# UNITED STATES PATENT AND TRADEMARK OFFICE

10/715,040

## Office Action Summary

A novel function, douche mode, is built into the hand-held and wall-mounted showerheads for women's personal hygiene

FIG. 3

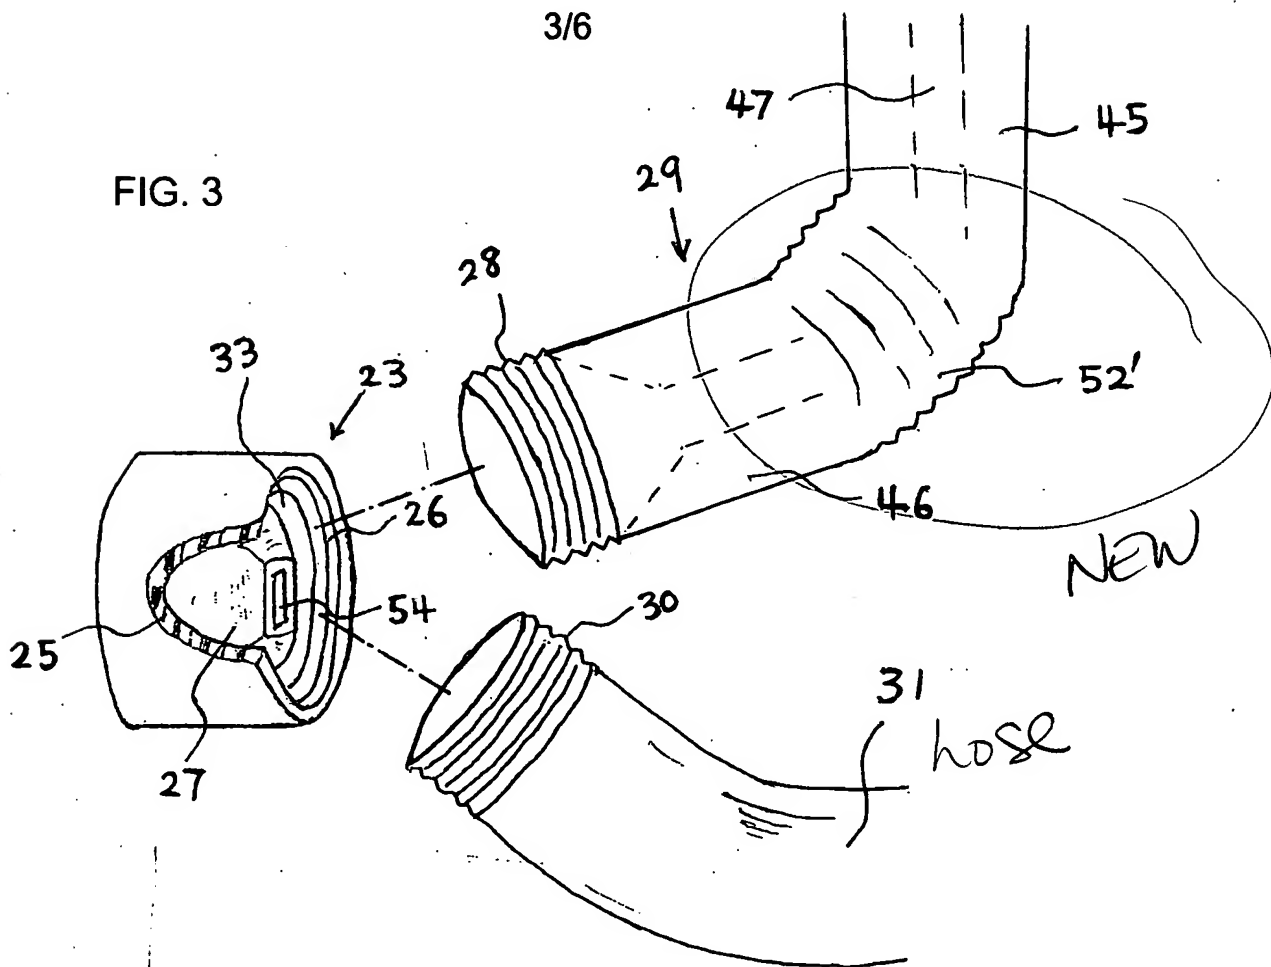
The drawings are objected to because Applicant has shown new matter in figures 3-4 with respect to element 52'.

shall introduce new matter into the disclosure of the invention. The added material which is not supported by the original disclosure is as follows: The element 52' in figures 3-4. Any reference to reference numeral 52' in the drawings or in the disclosure should be removed. The specification which includes the reference of Gauthier 3921635. This information was not as originally filed. Applicant should be arguing this reference that the Examiner presented in the office action under the heading arguments and should not be amending the specification to include this reference or any new information which pertains to this reference into his/her disclosure.( See page 4 paragraph 2 of applicant's sub specification.)

Applicant is required to cancel the new matter in the reply to this Office Action. Applicant is requested to submit a marked up and clean copy of a substitute specification.

FIG. 5

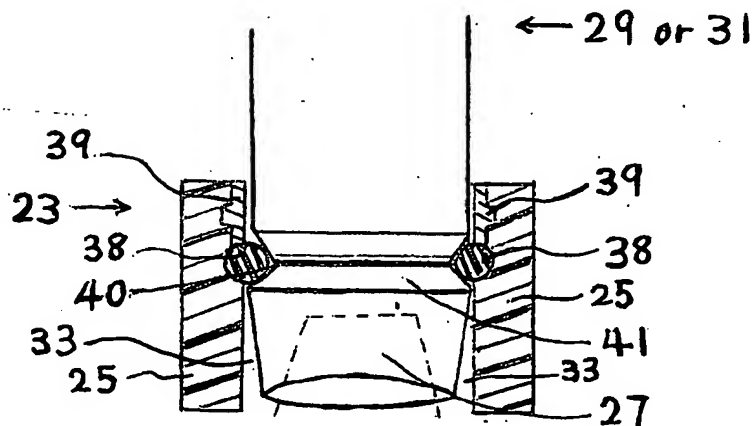
Not ok  
1/5/17
